TSB #	TSB 17-002		
Description/Title:	Axis/Vegas Hood Bracket Modification for Wiper System Clearance		
Affected Product Line(s):	Certain 2018 Axis/Vegas Motorhomes		
Service Campaign # :	RC000139	Released Date:	7/12/2017
Failure Code:	TMCTS80293W	Document Date:	7/12/2017
Time Allowed:	0.5 hr	Document Revision:	A

Figure 1

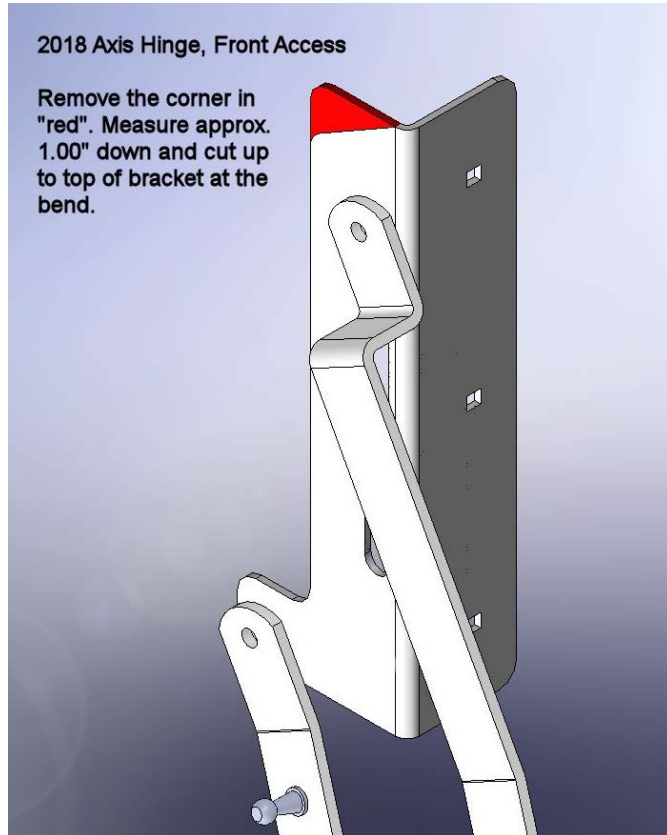
- 1. Open the hood.**
- 2. Access the driver's side hood hinge bracket. It will be just beneath the lower right hand corner of the hood opening. See figure 1/**
